**CITY OF WESTLAKE**  
**Engineering Department**  
4001 Seminole Pratt Whitney Road  
Westlake, Florida 33470  
Phone: (561) 530-5880  
[www.westlakegov.com](http://www.westlakegov.com)

## STAFF MEMORANDUM

**DATE:** 4/22/2022  
**PETITION NO.:** ENG-2021-17  
**DESCRIPTION:** Review of Plat for Cresswind Palm Beach (Pod P-1) Phase 4  
**APPLICANT:** Cotleur & Hearing  
**OWNER:** KH Westlake, LLC  
**REQUEST:** Owner (KH Westlake, LLC) is requesting approval of the Plat for Cresswind Palm Beach (Pod P-1) Phase 4

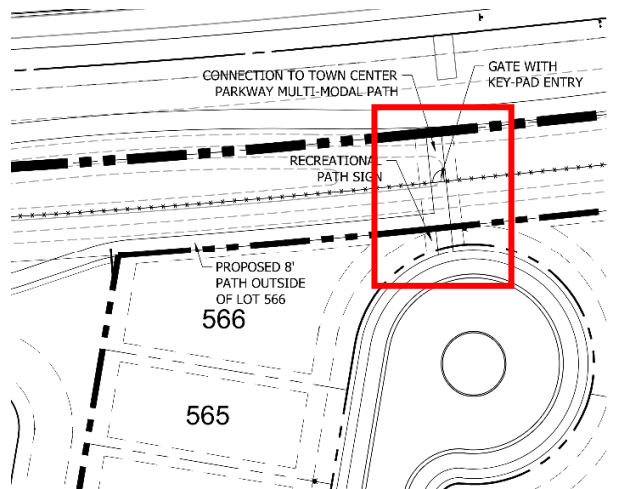
The subject application has a dead-end street with an approximate length of 1,660 feet. There is no mid-block pedestrian crossing proposed. This dead-end street is Hutchinson Way, circled in the image below.

The intent of this section of the LDRs is to promote development with less total travel time for residents. The longer block lengths cause both longer vehicular and pedestrian travel time for residents to reach a cross street.

To alleviate the longer pedestrian travel time caused by the block length of Hutchinson Way, the applicant has proposed a pedestrian connection to the pathway at Town Center Parkway. This proposed connection is shown in the image below.

It is assumed that the most frequent destinations for the residents to travel to from their house are the mail kiosk and Town Center Parkway. The distance to the mail kiosk is approximately the same with or without a mid-block crossing required by the LDRs. However, the distance to the multi-modal pathway on Town Center Parkway is substantially shorter with the proposed pedestrian connection gate on the north side of Hutchinson Way.

The proposed waiver of block length, along with additional pedestrian connections to the multi-modal pathway system, was reviewed by the Engineering Department. These additional pedestrian connections are a benefit to the residents.

We therefore recommend that the plat be approved for recording and the accompanying waiver be approved.
